ADDENDUM NO. 2

- A. Date: 19 March 2013
- B. From: Bahr Vermeer and Haecker Architects, Ltd.
- C. To: Prospective Bidders.
- D. Project: Lexington Public Schools Lexington Middle School and Community Recreation Facility Addition 100% Contract Documents
- E. This addendum is issued by the Architect to all bidders of record prior to receipt of proposals. Bidders shall acknowledge receipt of this addendum by so indicating on the Bid Form. Failure to do so may subject Bidder to disqualification.
- F. All information and instructions given herein shall become a part of the Contract Documents.

ADDENDUM # 2

PROJECT Lexington Middle School & CRF Addition

SHEET
M1.1C
 ATTACHMENT NO.

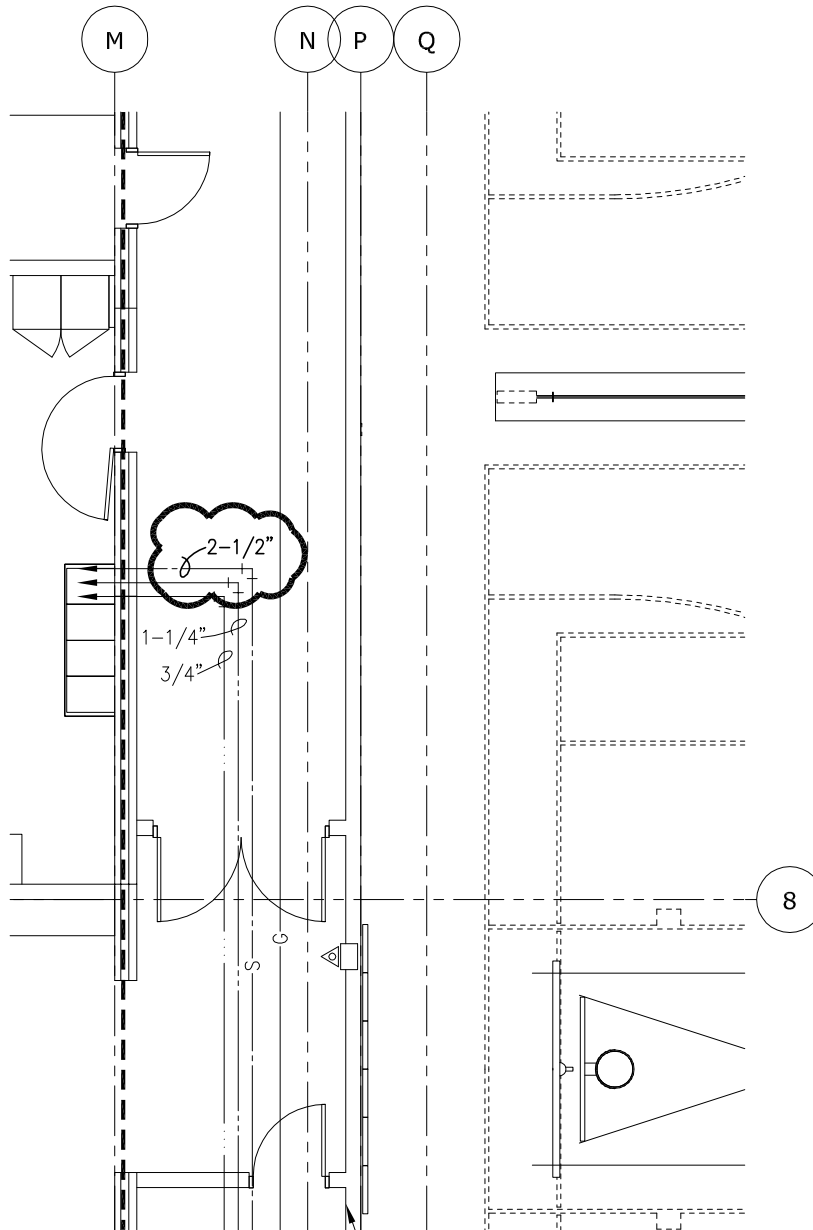
3. Sheet M1.1C First Floor Plan – Area C - Plumbing
 - A. See sheet M1.1C-1 for changes to the plumbing plan.
 - B. See sheet M1.1C-2 for changes to the plumbing plan

M1.1C

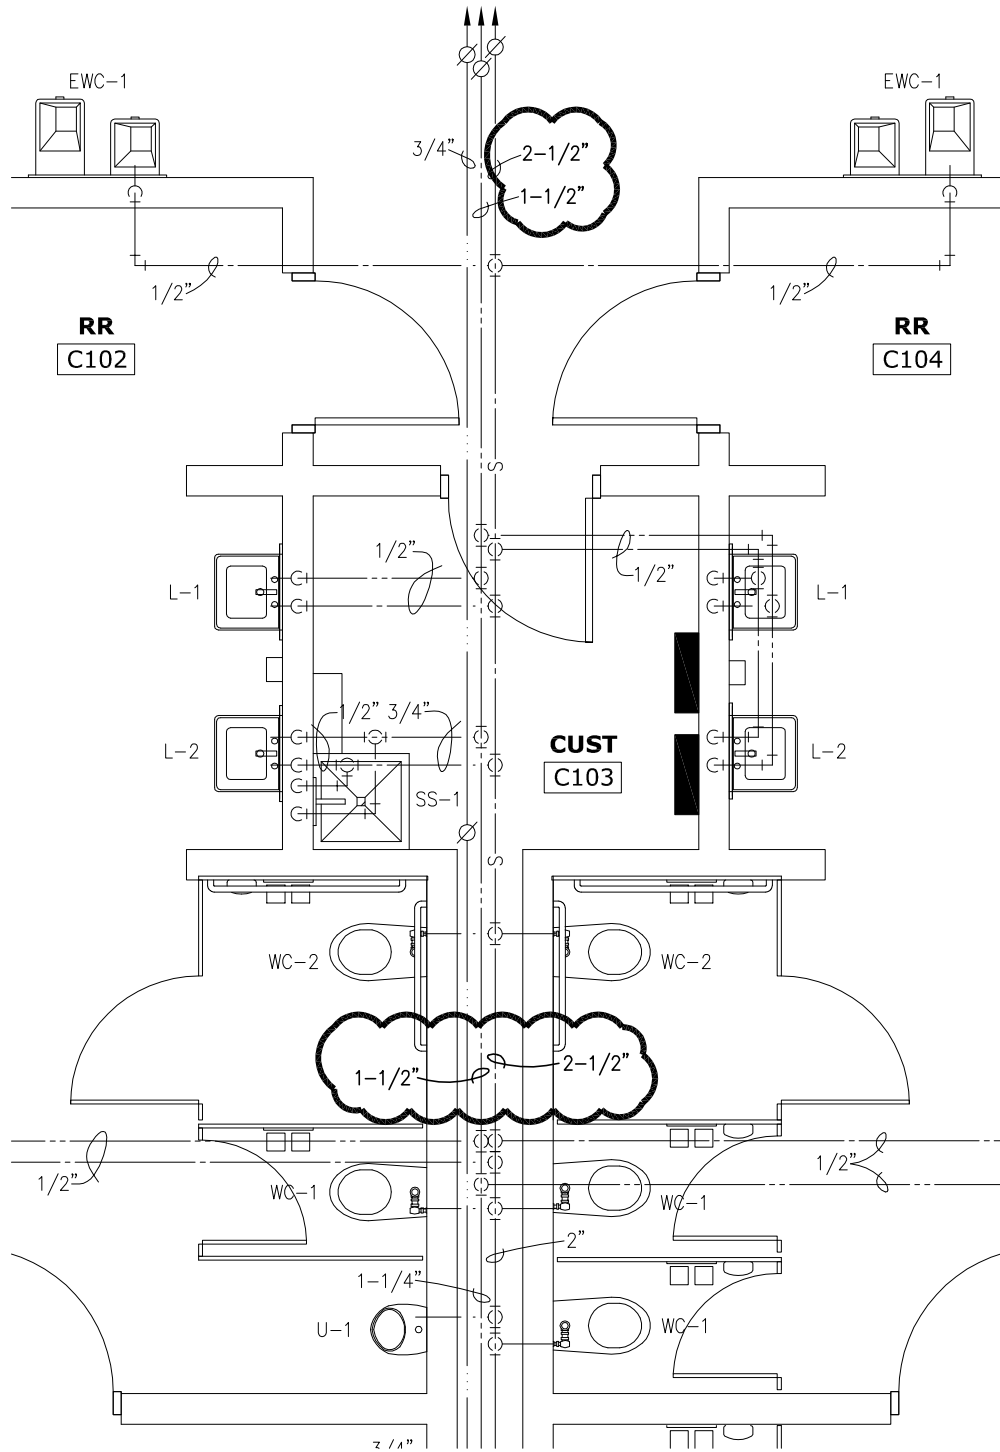
- C. See sheet M1.1C-3 for changes to the plumbing plan
 - D. See sheet M1.1C-4 for changes to the plumbing plan
4. Sheet M1.1D First Floor Plan – Area D - Plumbing

M1.1D

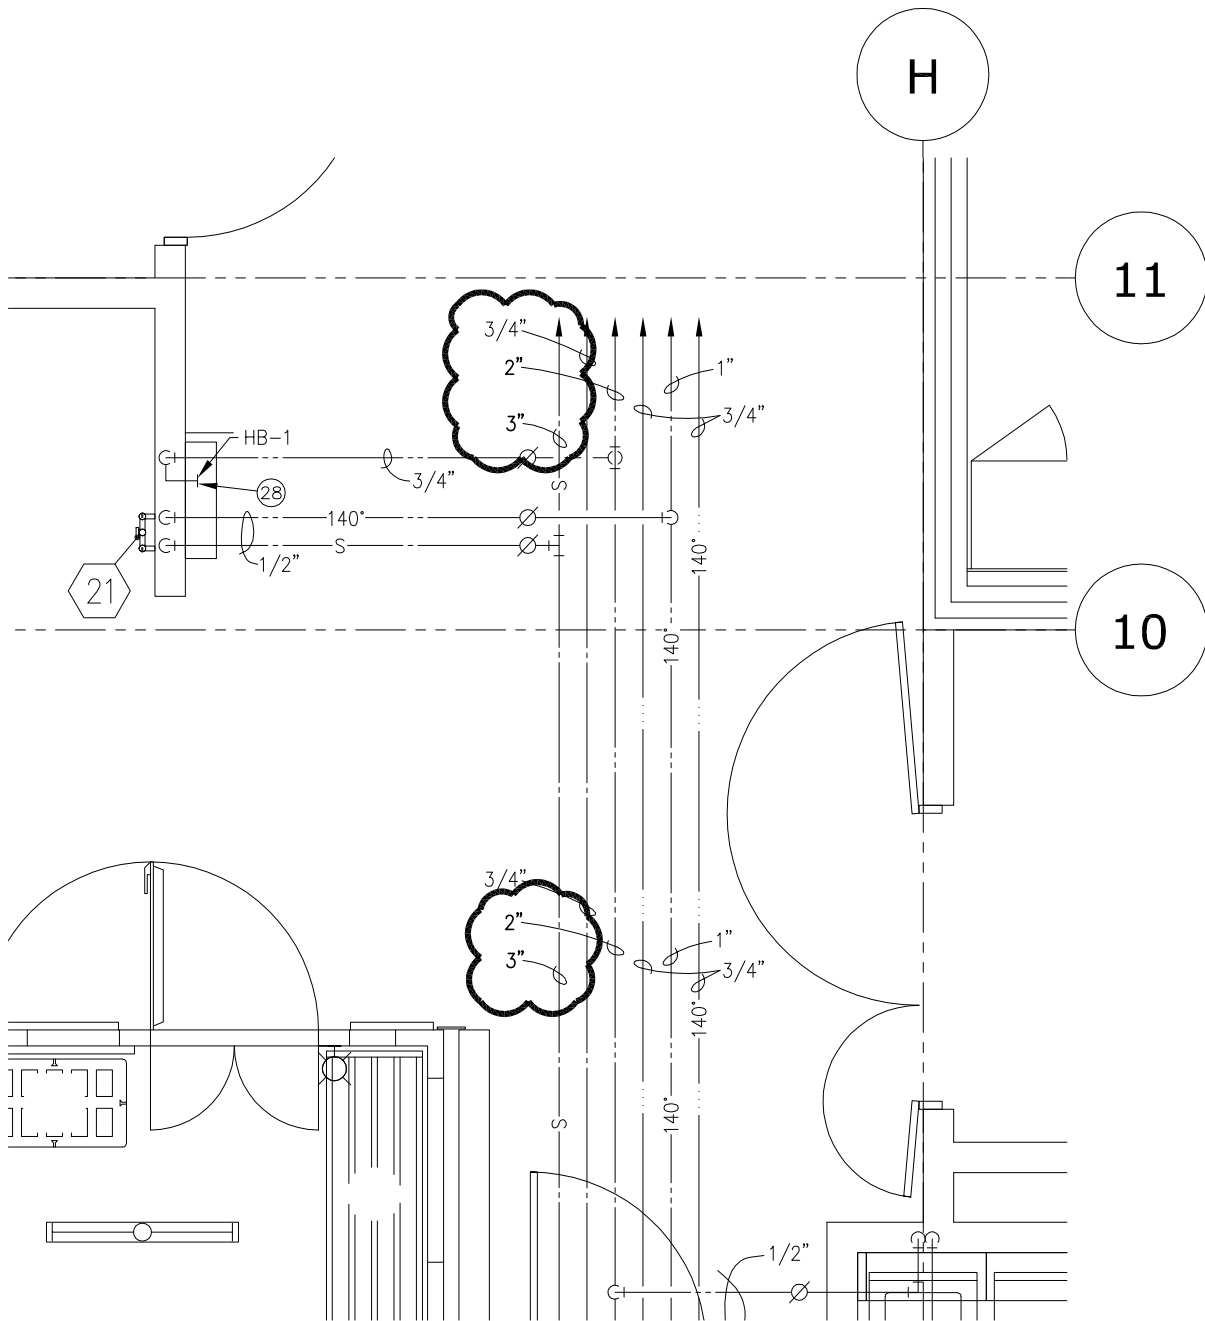
- A. See sheet M1.1D-1 for changes to the plumbing plan.
5. Sheet M1.1K Enlarged Kitchen - Piping Plan
 - A. See sheet M1.1K-1 for changes to the plumbing plan.

M1.1K

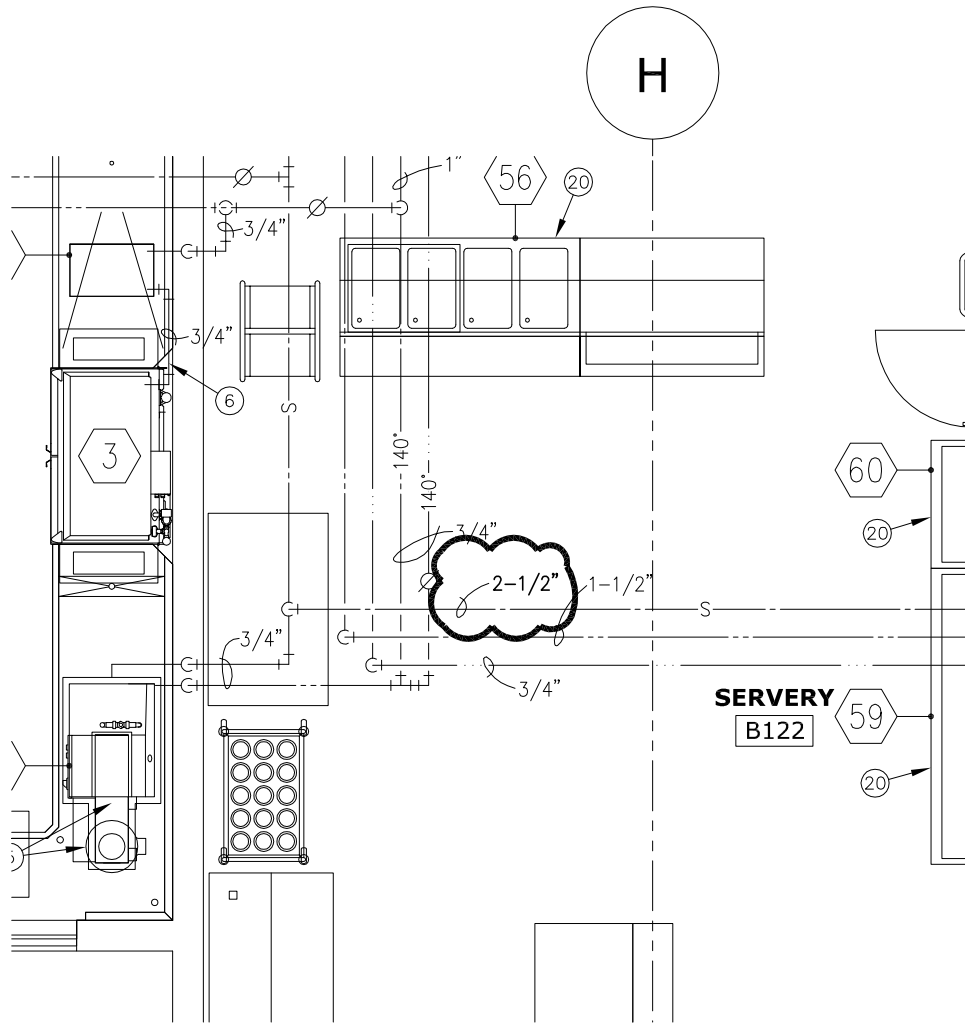
- B. See sheet M1.1K-2 for changes to the plumbing plan.
 - C. See sheet M1.1K-2 for changes to the plumbing plan.
 - D. See sheet M1.1K-2 for changes to the plumbing plan.

SHEET
M1.2C
ATTACHMENT NO.

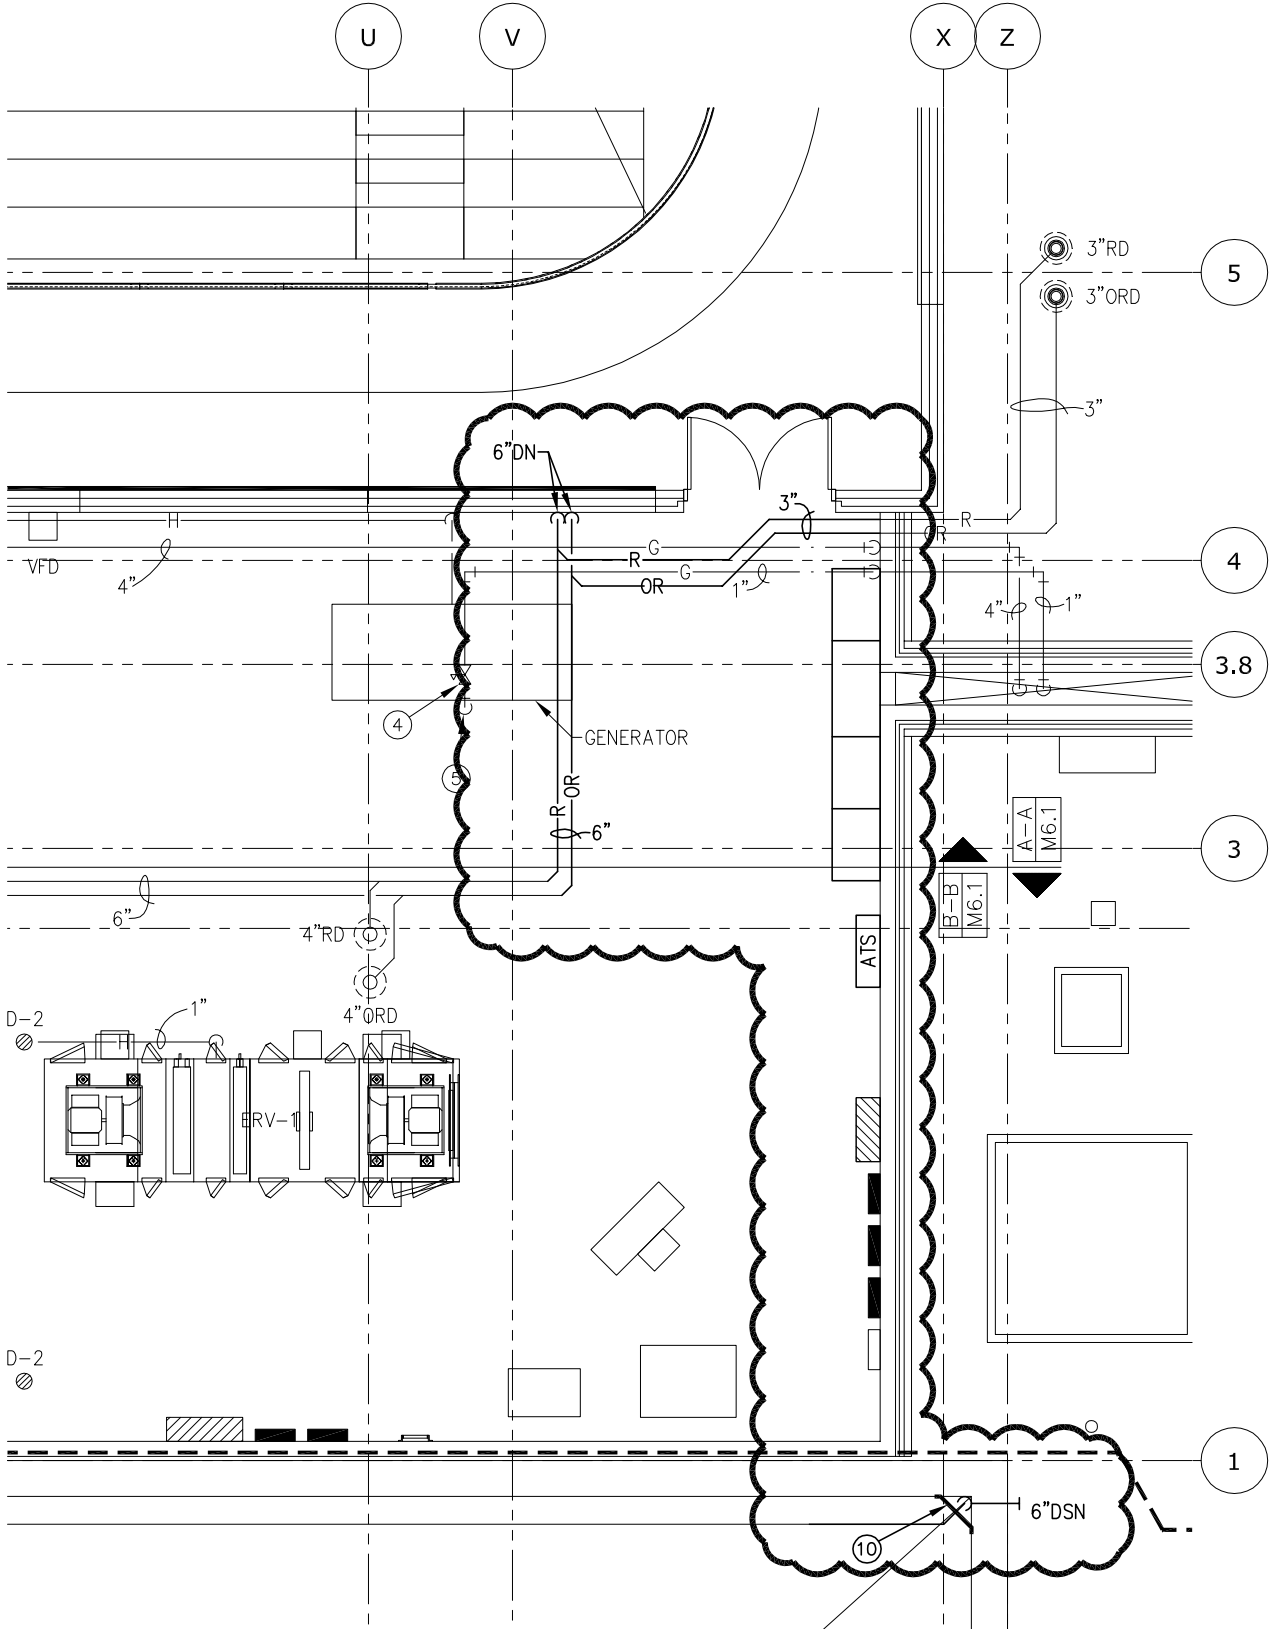
6. Sheet M1.2C Second Floor Plan – Area C – Plumbing
 - A. See sheet M1.2C-1 for changes to the plumbing plan and added sheet note number 10.
 - B. See sheet M1.2C-2 for changes to the existing Gymnasium rainwater and added sheet note number 9.

- FIELD FABRICATE STEEL PROTECTIVE COVER TO PROTECT PIPING. PROVIDE 1/8" THICK STEEL PANEL, 6 FEET TALL. INSTALL BOTTOM OF PANEL 12" AFF. PRIME AND PAINT PANEL TO MATCH WALL. PROVIDE PVC JACKET OVER INSULATION ON ENTIRE VERTICAL OVERFLOW PIPING.

SHEET
M1.2C
ATTACHMENT NO.

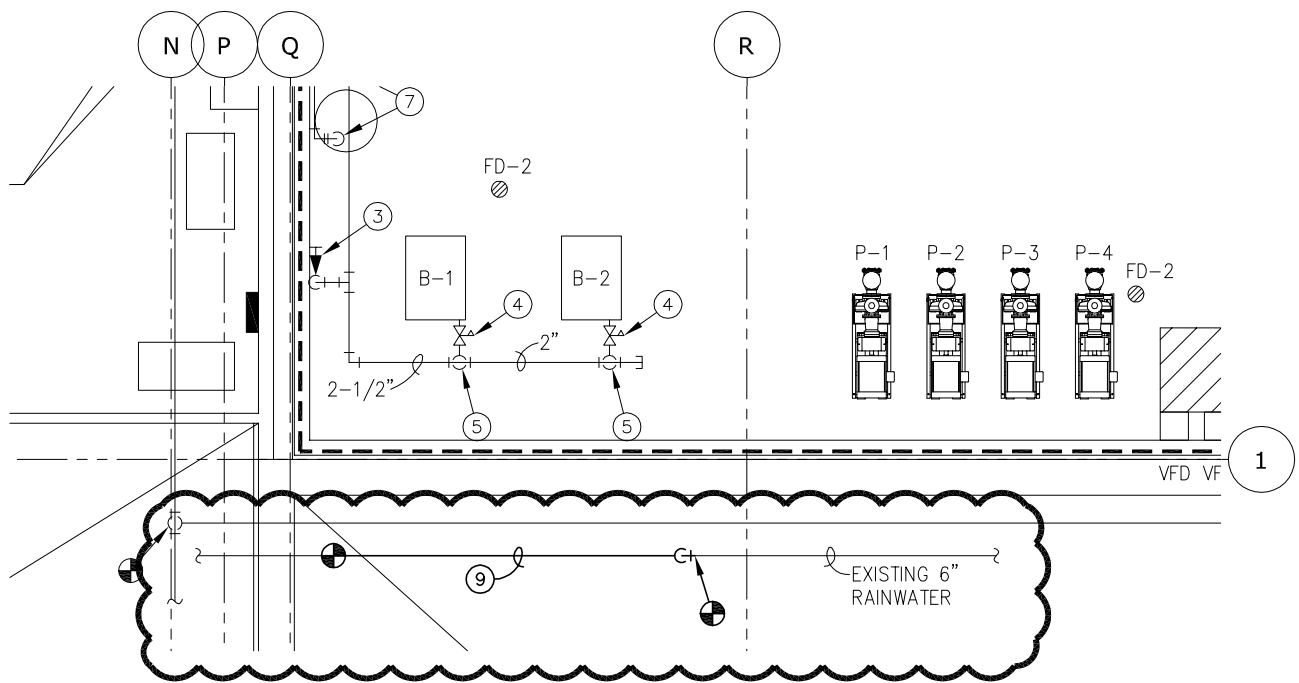
9. OFFSET EXISTING RAINWATER PIPING DOWN FOR NEW SUPPLY AND RETURN DUCTWORK.

3/19/13
SHEET
M2.2A
ATTACHMENT NO.
1
NJS

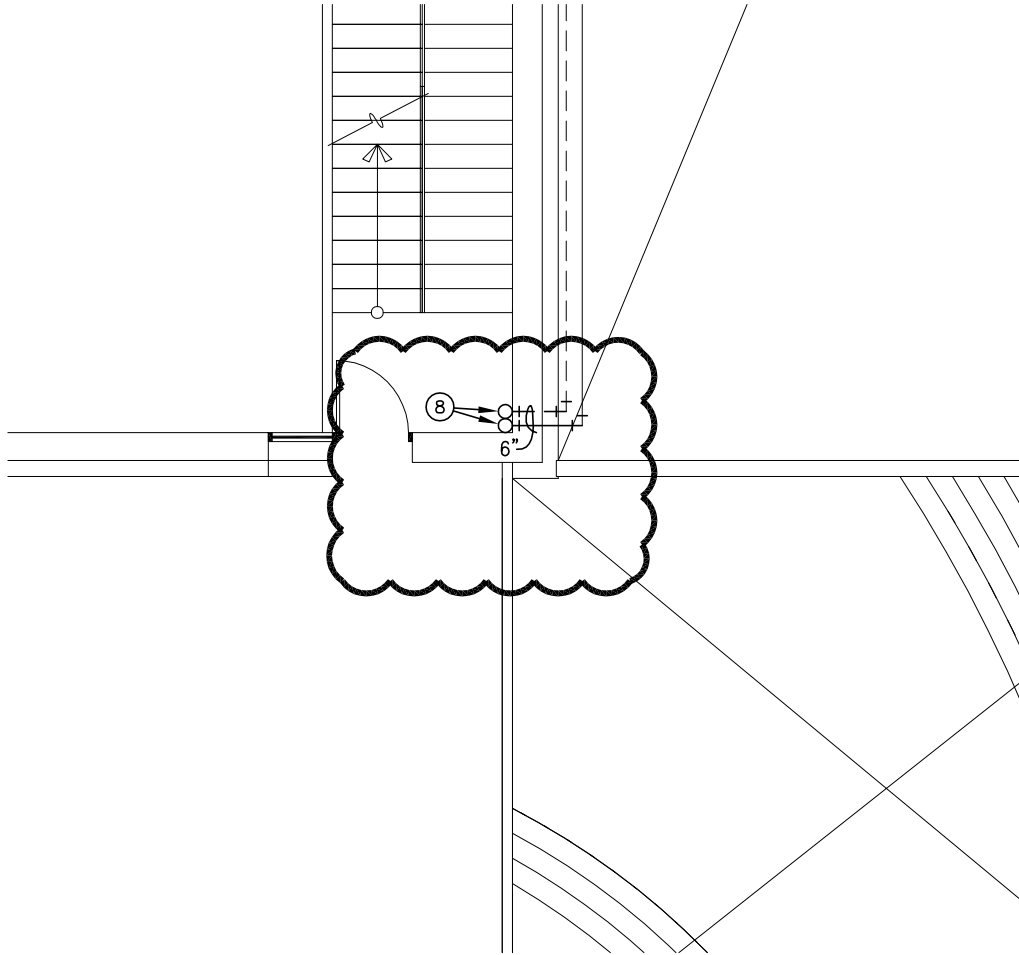
7. Sheet M2.2A Second Floor Plan – Area A - Mechanical
 - A. See sheet M2.2A-1 for changes to the mechanical plan and sheet note number 1.
 - B. See sheet M2.2A-2 for changes to the mechanical plan.
